# Access Compliance Report

## Public Rights-of-Way

Intersection ID: 14049	Main Street: CLEMENT_AV	Cross Street: PARK_DR	Location: E
ADA ID: C76138D66AC1	Ramp Type: PerpDiag	Initial Pass/Fail: Fail	Overall Compliance: No
Codes/Mitigation Info/Possible Solution		Field Measurements/Component Compliance	
Severity Score: 12.5

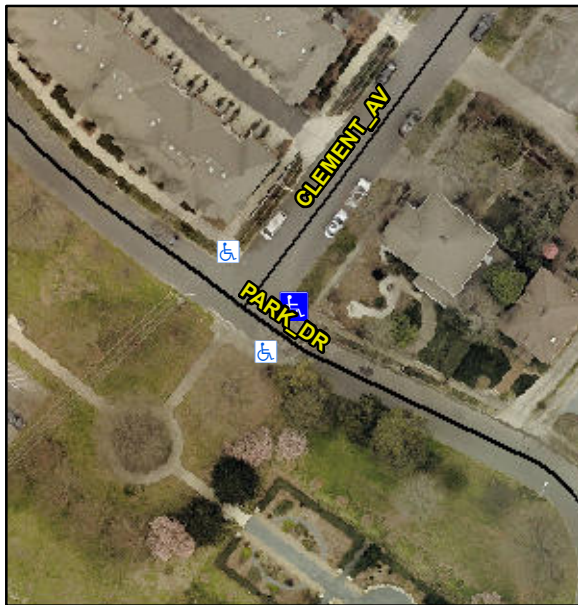
**Not Found, R304.2.2**

Compliance	Description	Data	Compliance	Description	Data
N/A	Ramp Length (in)	36.0	No	Ramp Slope (%)	10.7
Yes	Ramp Width (in)	48.0	Yes	Ramp XSlope (%)	2.0
N/A	Flare Type LT	N/A	N/A	Flare Type RT	N/A
N/A	Flare Slope LT (%)	N/A	N/A	Flare Slope RT (%)	N/A
N/A	Flare Traversable LT?	N/A	N/A	Flare Traversable RT?	N/A
N/A	Landing Length (in)	N/A	N/A	DWS Provided?	N/A
N/A	Landing Width (in)	N/A	N/A	DWS Contrast?	N/A
N/A	Landing Slope (%)	N/A	N/A	DWS Length (in)	N/A
N/A	Landing X Slope (%)	N/A	N/A	DWS Full Width?	N/A
N/A	Landing Curb? (Y/N)	N/A	N/A	DWS Offset (in)	N/A
N/A	Shared Landing?	N/A			
N/A	Gutter Ponding?	N/A	N/A	Gutter Slope (%)	N/A
N/A	Gutter Lip Ht (in)	N/A	N/A	Gutter X Slope (%)	N/A
N/A	Painted X Walk1?	No	N/A	Painted X Walk2?	No
	X Walk 1 Direction	To NW		X Walk 2 Direction	To SW
N/A	X Walk 1 Width (in)	N/A	N/A	X Walk 2 Width (in)	N/A
	X Walk 1 Slope (%)	5.4		X Walk 2 Slope (%)	3.3
	X Walk 1 X Slope (%)	3.0		X Walk 2 X Slope (%)	4.1

**Remove & Replace Curb Ramp With Two New Directional Ramps or Equivalent.**
